**BASEBALL STADIUM IN THE  
DIRIDON/ARENA AREA**

**FINAL ENVIRONMENTAL IMPACT REPORT  
VOLUME III**

APPENDIX I: First Amendment to Environmental Impact  
Report (Response to Comments)

BASEBALL STADIUM IN  
THE DIRIDON/ARENA AREA  
ENVIRONMENTAL IMPACT REPORT

FIGURE 1

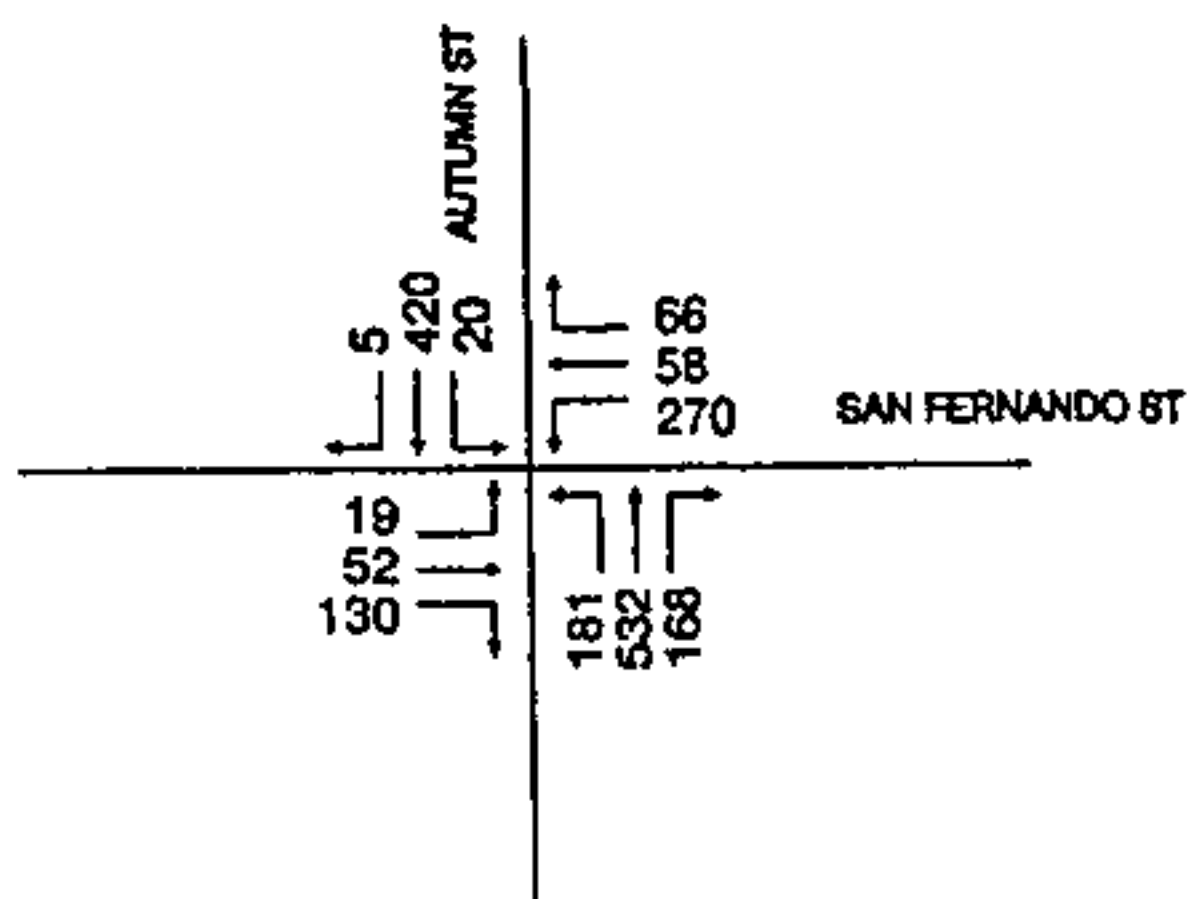
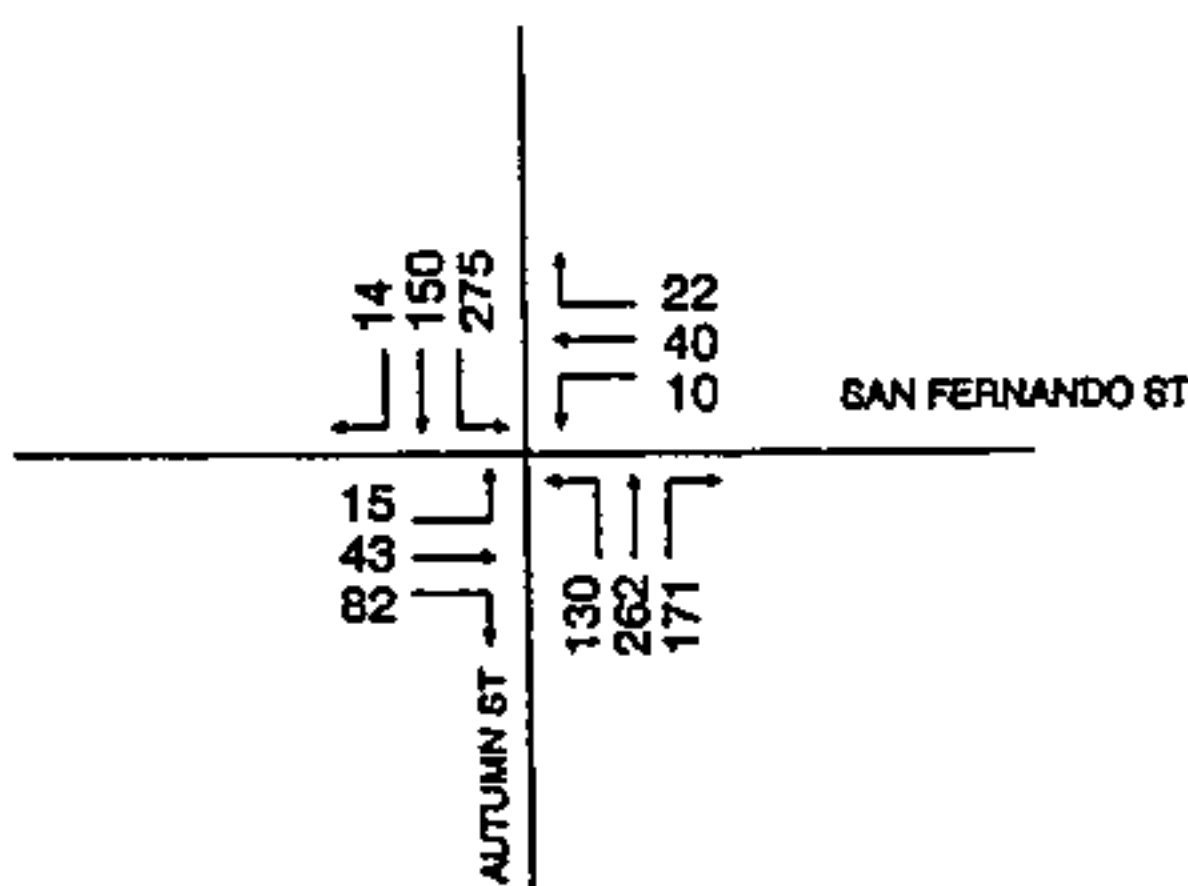
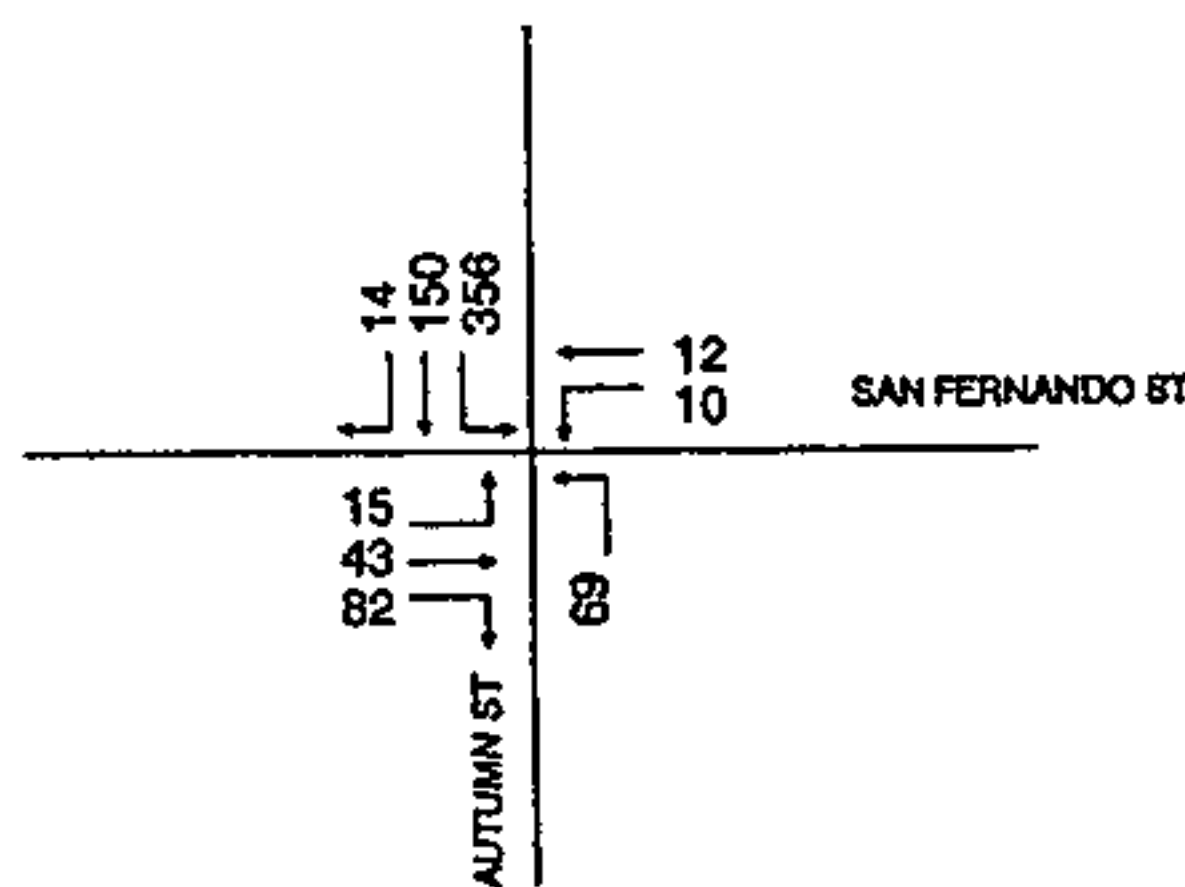
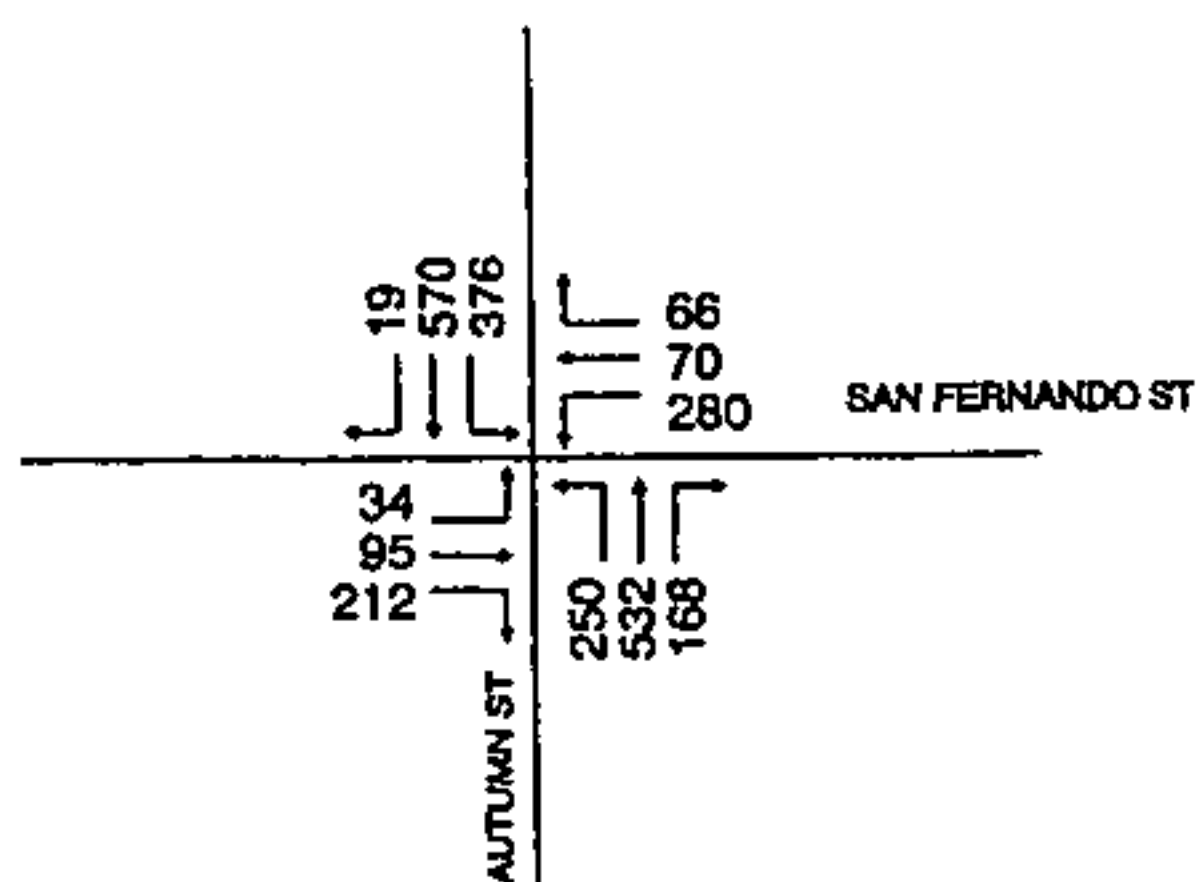
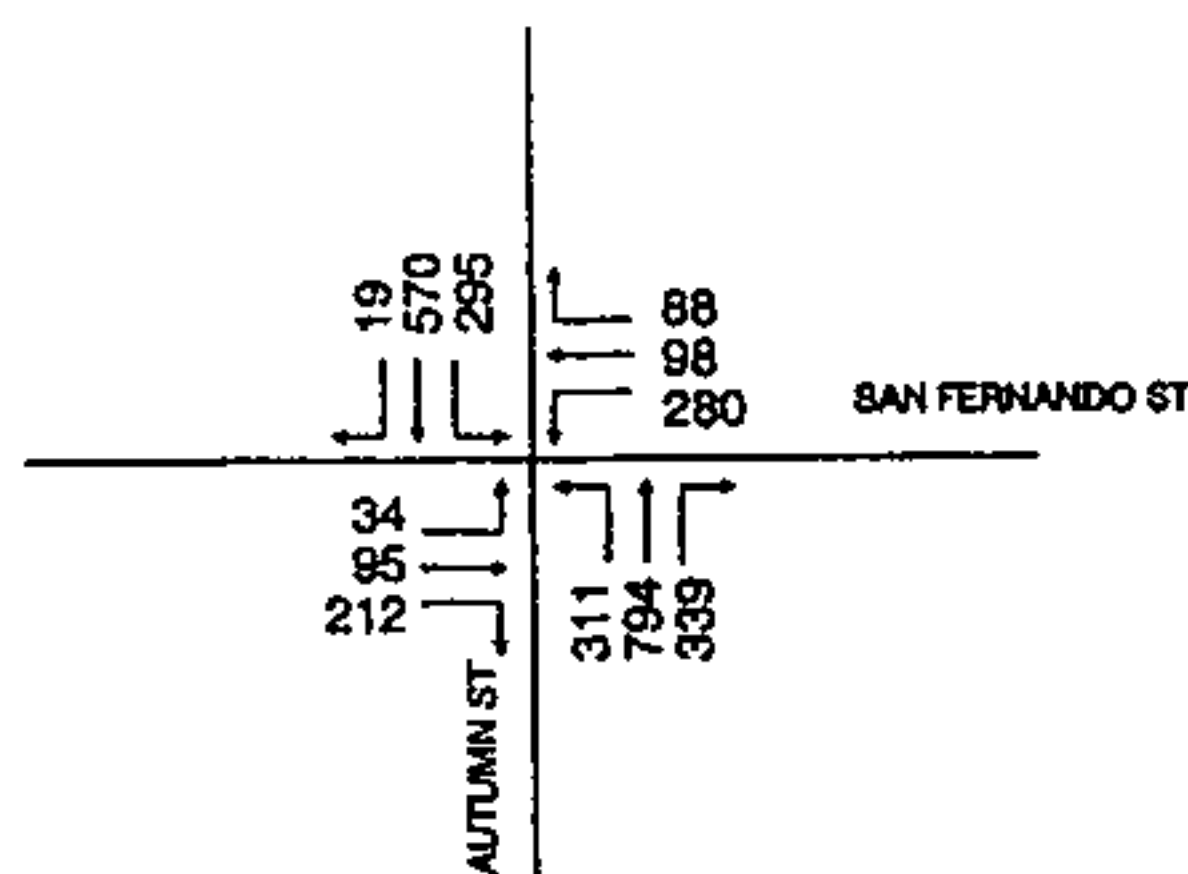
Figure 1 shows the dramatic increase that would occur in volumes through the Autumn Street/West San Fernando Street intersection if motorists traveling to the stadium follow the same routing patterns for a simultaneous event condition as they would for the condition with just a baseball game. Figure 2 shows similar results for the Autumn Street/Park Avenue intersection. A large portion of HP Pavilion customers approach HP Pavilion from the south on Autumn Street, via the Bird Avenue/I-280 interchange. Thus, it is critical for HP Pavilion that the intersections of Autumn Street with West San Fernando Street and Park Avenue provide effective traffic operations.
